UNITED STATES
NUCLEAR REGULATORY COMMISSION
REGION I
631 PARK AVENUE
KING OF PRUSSIA, PENNSYLVANIA 19406

Subject: Inspection 70-687/78-02

Subj: PROPOSED AMENDMENT TO SPECIAL NUCLEAR MATERIAL
(SNM) LICENSE No. 639.

FIGURE 1

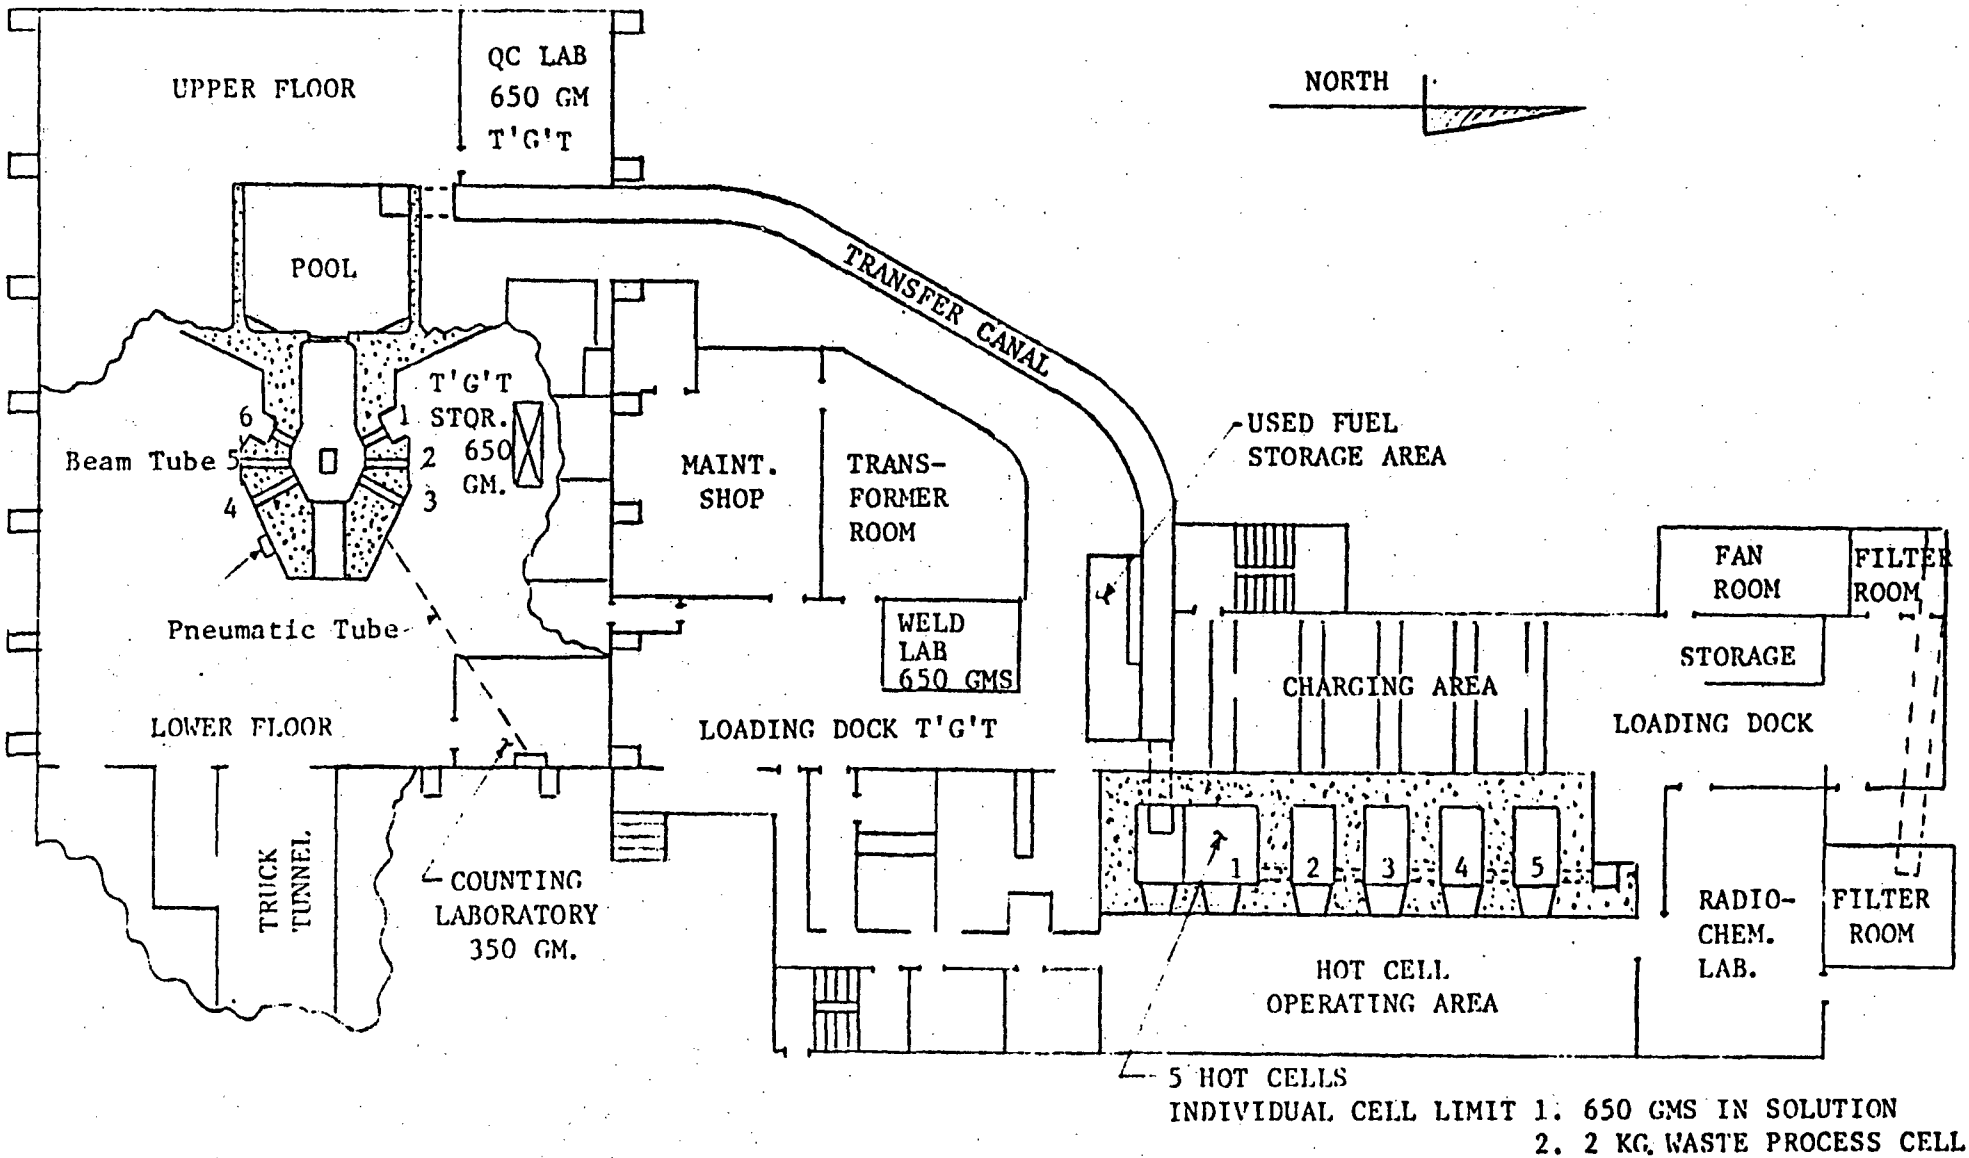
Revised floor plans are included to reflect the current storage locations and processing laboratories. A check in the amount of \$150.00 is enclosed to cover the administrative fee requirements of 10 CFR 170.31.

FIGURE 1A

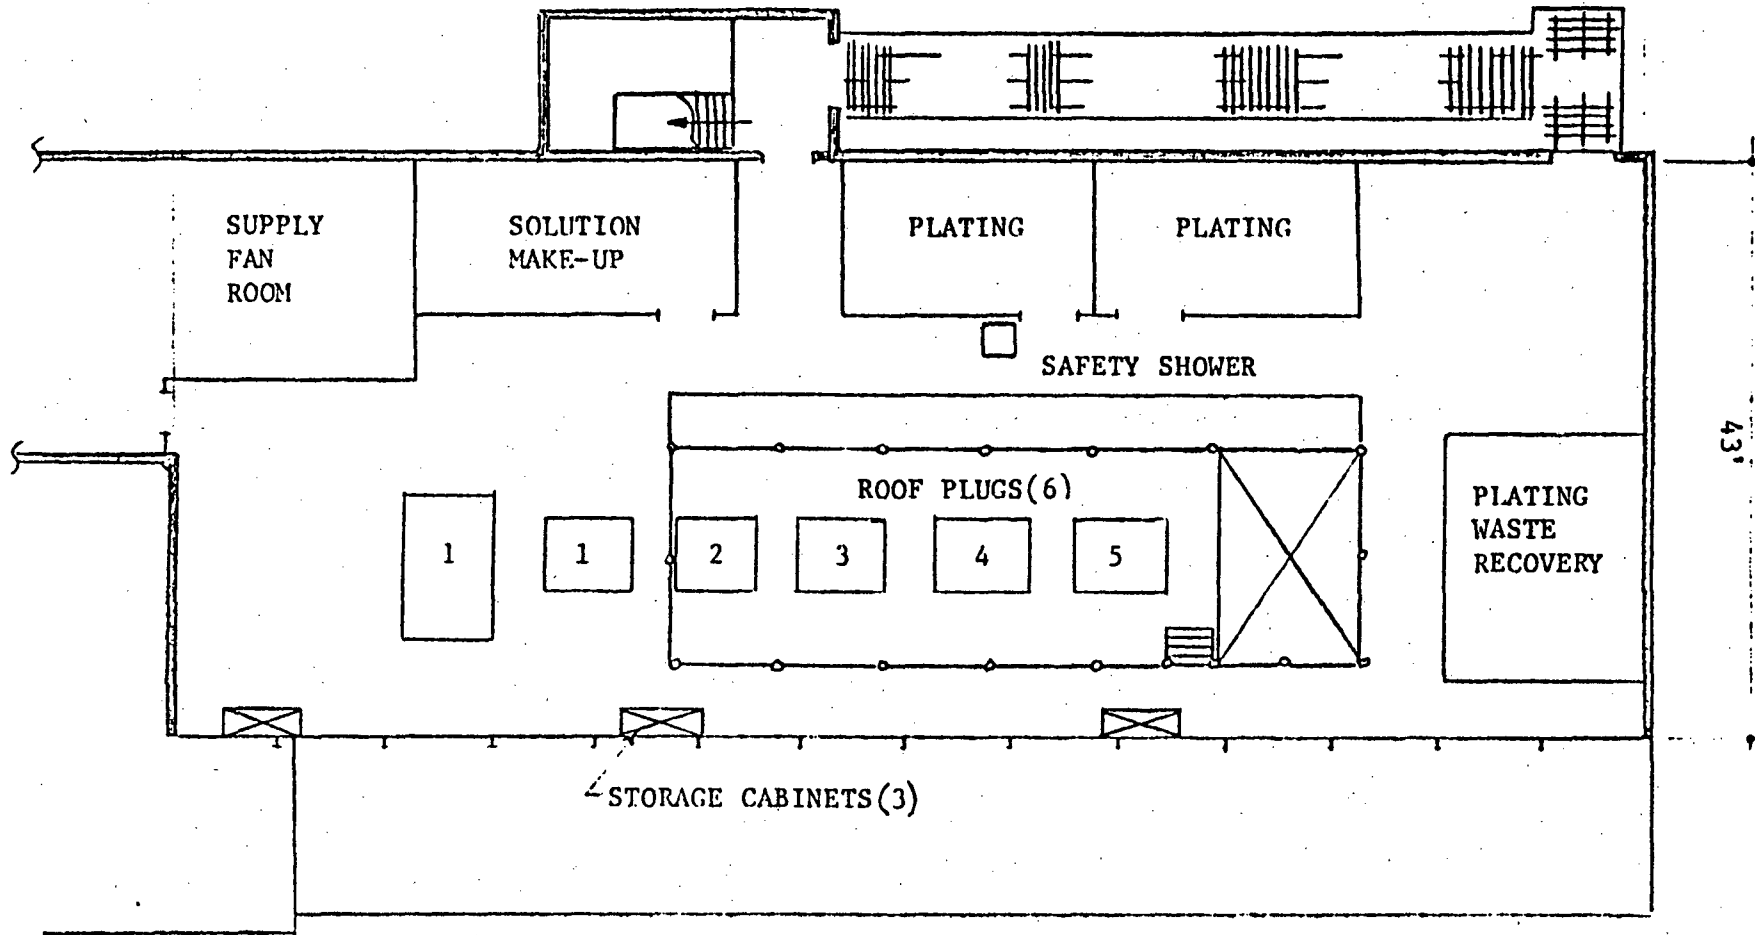
Uranium is stored in storage cabinets in the upper level of the hot laboratory (Fig. 1A). Material in liquid form is doubly contained. Storage cabinets are of fireproof construction, are separated by a minimum distance of three feet and are fastened to prevent inadvertent movement. All cabinets are locked and keys are in the custody of the SNM custodian for the area. Criticality control is implemented by limiting the quantity of SNM in solution to 350 grams per storage cabinet. This limit allows a safe margin below the single parameter limit of 760 grams U-235 in uniform aqueous solutions specified in the ANSI N16.1-1969 standard even

- "A.3. Unirradiated SNM in solution shall not exceed 350 grams in a single laboratory."
- "A.4. SNM, as an oxide, encapsulated for irradiation shall not exceed 650 grams in a single laboratory. When SNM is in process in the plating lab (Fig. 1A), it can be either as a solid (oxide) or in solution (electrolyte 15 gms/liter, H:U = 1500) and the quantity of either form shall be governed by the formula:

"B.a. para. 1 Criticality Control In Storage Areas

"B.b. para. 2 Criticality Control In Chemistry Laboratory
